Access Compliance Report

Public Rights-of-Way

(Curb Ramps)

Intersection ID: 9440	Main Street: BRADFORD_DR	Cross Street: EDGEWOOD_RD	Location:	N
ADA ID: 35F45E1ABEFE	Ramp Type: Perp	Initial Pass/Fail: Fail	Overall Compliance: No	Severity Score: 13.75

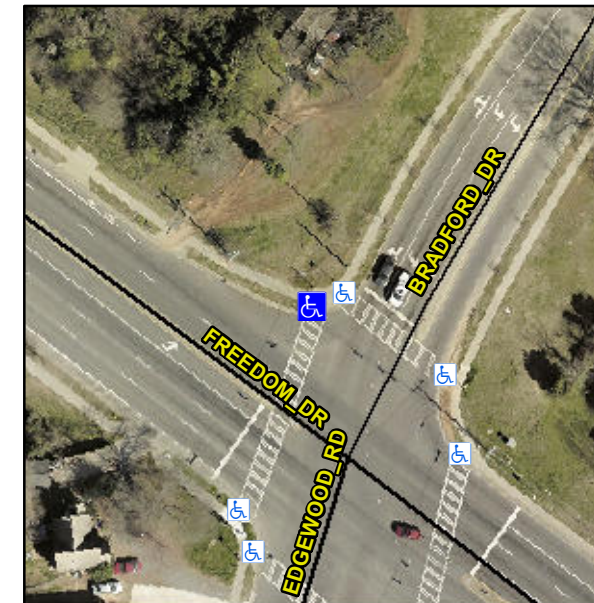
Not Found, R304.2.2

Compliance	Description	Data	Compliance	Description	Data
N/A	Ramp Length (in)	60.0	No	Ramp Slope (%)	8.9
Yes	Ramp Width (in)	48.0	Yes	Ramp XSlope (%)	2.9
N/A	Flare Type LT	N/A	N/A	Flare Type RT	N/A
N/A	Flare Slope LT (%)	N/A	N/A	Flare Slope RT (%)	N/A
N/A	Flare Traversable LT?	N/A	N/A	Flare Traversable RT?	N/A
N/A	Landing Length (in)	N/A	N/A	DWS Provided?	N/A
N/A	Landing Width (in)	N/A	N/A	DWS Contrast?	N/A
N/A	Landing Slope (%)	N/A	N/A	DWS Length (in)	N/A
N/A	Landing X Slope (%)	N/A	N/A	DWS Full Width?	N/A
N/A	Landing Curb? (Y/N)	N/A	N/A	DWS Offset (in)	N/A
N/A	Shared Landing?	N/A			
N/A	Gutter Ponding?	N/A	N/A	Gutter Slope (%)	N/A
N/A	Gutter Lip Ht (in)	N/A	N/A	Gutter X Slope (%)	N/A
N/A	Painted X Walk1?	Yes	N/A	Painted X Walk2?	N/A
	X Walk 1 Direction	To SW		X Walk 2 Direction	N/A
N/A	X Walk 1 Width (in)	116.0	N/A	X Walk 2 Width (in)	N/A
	X Walk 1 Slope (%)	0.7		X Walk 2 Slope (%)	N/A
	X Walk 1 X Slope (%)	3.9		X Walk 2 X Slope (%)	N/A

Remove & Replace Entire Ramp.
